WOLF CREEK

Subject: Docket No. 50-482: Revision to Technical Specifications
to Implement Cycle 9 Reactor Coolant System Thermal
Design Flow Reduction

ATTACHMENT I
SAFETY EVALUATION

Figure 1 : Core Thermal Limit Protection

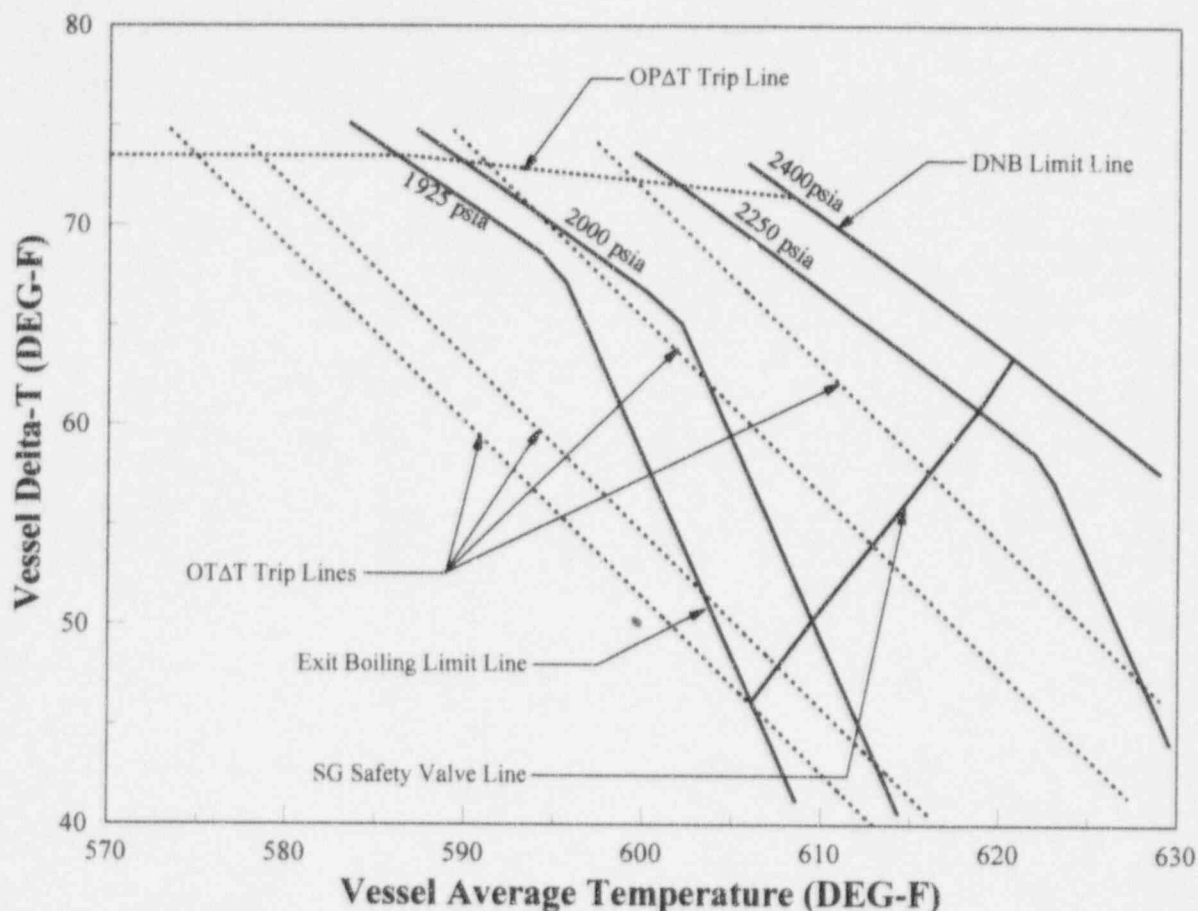
Protection of the core thermal limits is illustrated in the WCGS USAR Figure 15.0-1 and is provided in Figure 1 below. The figure demonstrates that the OTAT and OPAT protection system setpoints and the steam generator safety valves prevent violation of the vessel exit boiling limits, Departure from Nucleate Boiling Ratio (DNBR) correlation exit quality limit, and DNB limits for a range of pressurizer pressures which bound allowable operating space. This range is defined by the Low and High Pressurizer Pressure trip setpoints.

Changes in the primary side parameters associated with the reduction in thermal design flow affect the core thermal limit calculations. The reduction in flow penalizes the calculated limits, restricting the range of allowable operating space. Thus, the core thermal limits have been revised to account for the reduction in design flow.

The vessel exit boiling limit lines are a family of curves which represent the locus of points at which the vessel exit enthalpy is equal to the saturation enthalpy at the applicable system pressure. While the vessel exit boiling limits do not serve a direct function in core protection, it is necessary to limit the vessel exit enthalpy to a subcooled state, since many of the reactor protection system functions use vessel ΔT as indicator of core power. The inherent assumption in these protection system functions is that vessel ΔT is proportional to core power; a valid assumption as long as the coolant remains subcooled. Thus, to guarantee that vessel ΔT remains proportional to power, the core exit enthalpy is restricted such that exit boiling will not occur.

The core DNE limit lines are lines of constant DNBR below which there is a 95% probability at the 95% confidence level that DNB will not occur during normal operation, operational events, or as a result of conditions arising from any fault of moderate frequency. The reduction in thermal design flow results in

restrictions on allowable operating space. However, examination of the OTAT and OPAT trip functions indicate that these restrictions are bounded.

An additional effect of the reduction in thermal design flow is a change in the location of the steam generator safety valve line resulting from the changes in secondary side parameters. This line, which represents the locus of conditions under which the steam generator safety valves open, shifts such that a broader range of attainable operating conditions exist. Initial evaluation of the core thermal limit protection with the revised position of the steam generator safety valve limit line indicated violations in the Vessel exit boiling limits for low values of system pressure. Restricting the allowable pressure range at the low end produces margin to the corresponding pressure OTAT trip setpoint conditions. The low end of the allowable system pressure range is defined by the Low Pressurizer Pressure trip setpoint. The system pressure range was therefore shortened by increasing this setpoint. An increase in the Low Pressurizer Pressure trip setpoint safety analysis limit from the current value of 1915 psig to 1940 psig ensures that the revised Vessel exit boiling limits are protected by the existing OTAT trip setpoint safety analysis limit and the revised steam generator safety valve limit lines.
